ADDENDUM No. 1 TO ORIGINAL INVITATION TO BID

BID NO.: 5617-2021 Gilchrist Elementary School Building 9 HVAC Replacement

Addendum #1
Gilchrist Equipment Replacement
TALLAHASSEE, FLORIDA
August 07, 2020
H2ENGINEERING PROJECT NO. 14-83

FLOOR PLAN
 SCALE: 1/8" = 1'-0"

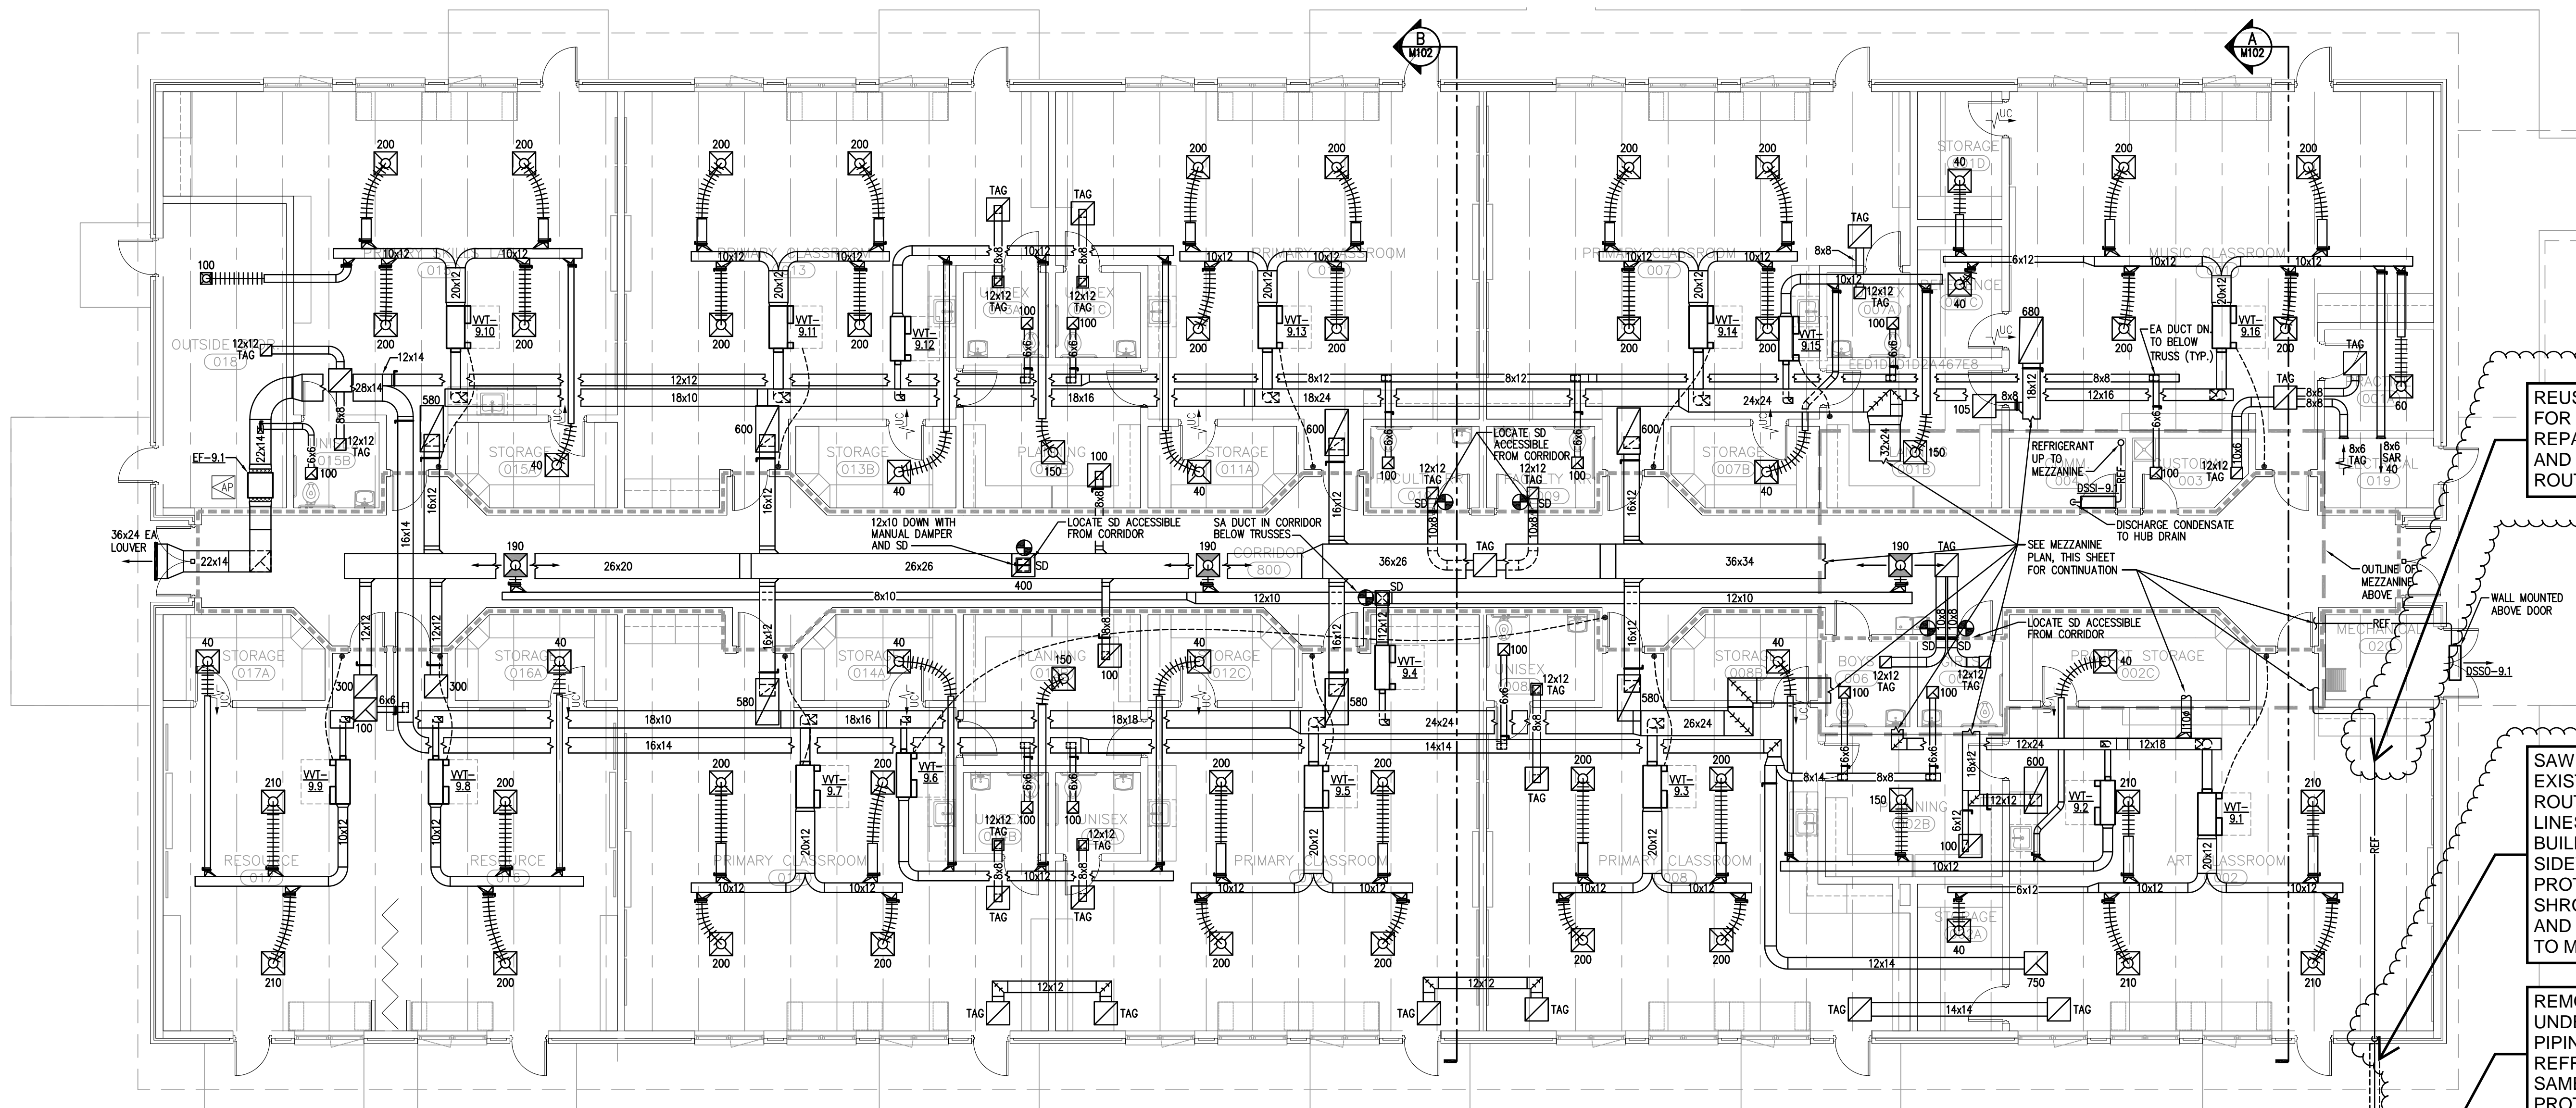
- a. Added additional instructional notes based on discussions had during the pre-bid meeting.

REUSE EXISTING PIPE HANGERS FOR NEW REFRIGERANT PIPING. REPAIR/REPLACE CEILING TILES AND GRID ALONG REFRIGERANT ROUTING AS NECESSARY.

SAW CUT SIDEWALK, REMOVE EXISTING REFRIGERANT LINES, ROUTE NEW REFRIGERANT LINES UP EXTERIOR OF BUILDING. REPAIR/REPLACE SIDEWALK. PROVIDE PROTECTIVE SHEET METAL SHROUD TO ENCLOSE PIPING AND INSULATION. PAINT SHROUD TO MATCH EXISTING BUILDING.

REMOVE EXISTING UNDERGROUND REFRIGERANT PIPING, ROUTE NEW REFRIGERANT PIPING ALONG SAME ROUTE, REUSE EXISTING PROTECTIVE PVC PIPE.
